# Access Compliance Report

## Public Rights-of-Way

Intersection ID: 11306	Main Street: W_9TH_ST	Cross Street: N_SMITH_ST	Location: E
ADA ID: AC98197B0751	Ramp Type: PerpDiag	Initial Pass/Fail: Fail	Overall Compliance: No
		Severity Score: 10

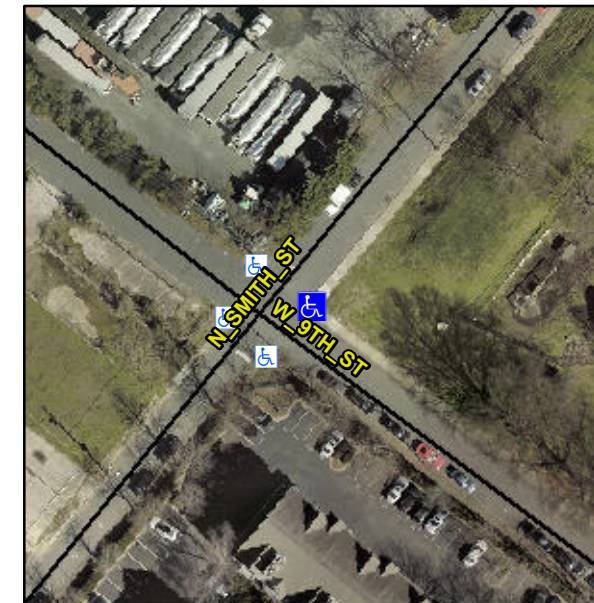
**R304.5.1, R304.5.3**

Compliance	Description	Data	Compliance	Description	Data
N/A	Ramp Length (in)	66.0	Yes	Ramp Slope (%)	7.8
No	Ramp Width (in)	36.0	No	Ramp XSlope (%)	4.8
N/A	Flare Type LT	N/A	N/A	Flare Type RT	N/A
N/A	Flare Slope LT (%)	N/A	N/A	Flare Slope RT (%)	N/A
N/A	Flare Traversable LT?	N/A	N/A	Flare Traversable RT?	N/A
N/A	Landing Length (in)	N/A	N/A	DWS Provided?	N/A
N/A	Landing Width (in)	N/A	N/A	DWS Contrast?	N/A
N/A	Landing Slope (%)	N/A	N/A	DWS Length (in)	N/A
N/A	Landing X Slope (%)	N/A	N/A	DWS Full Width?	N/A
N/A	Landing Curb? (Y/N)	N/A	N/A	DWS Offset (in)	N/A
N/A	Shared Landing?	N/A			
N/A	Gutter Ponding?	N/A	N/A	Gutter Slope (%)	N/A
N/A	Gutter Lip Ht (in)	2.0	N/A	Gutter X Slope (%)	N/A
N/A	Painted X Walk1?	No	N/A	Painted X Walk2?	No
	X Walk 1 Direction	To NW		X Walk 2 Direction	To SW
N/A	X Walk 1 Width (in)	N/A	N/A	X Walk 2 Width (in)	N/A
	X Walk 1 Slope (%)	3.7		X Walk 2 Slope (%)	6.3
	X Walk 1 X Slope (%)	1.7		X Walk 2 X Slope (%)	0.5

**Remove & Replace Curb Ramp With Two New Directional Ramps or Equivalent.**
